11-971111-CLN-01

TO: DISTRIBUTION
FROM: C NEUMEYER
SUBJECT: MINUTES OF VIDEO CONFERENCE ON PFCS

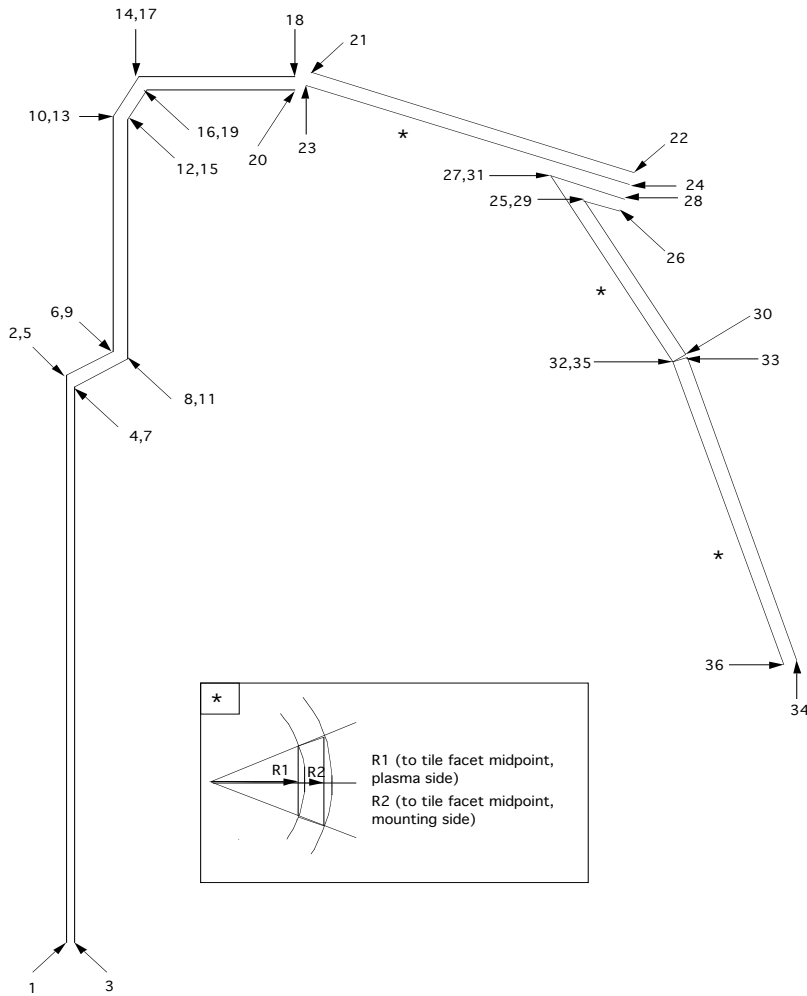
One possible exception is the back side of the conical sections of the inboard divertor. For thermal contact reasons, it may be desirable to make these flat. However, this will increase the machining complexity of the rings which make up these pieces. ACTION - J Chrzanowski to determine if machining of the rings with flats can be obtained without significant cost impact.

Basic dimensions given in the following figure and table were agreed to. They have been reviewed by physics (S Kaye, R Maingi). Details which need to be added however are as follows...

- tip at end of slot should have a radius of 1 cm
- gap between passive plates should be 1 in
- radius on tile at midplane end of primary passive plate should be 1"

ACTION - C Neumeyer to issue memo to document, and include notes about radii
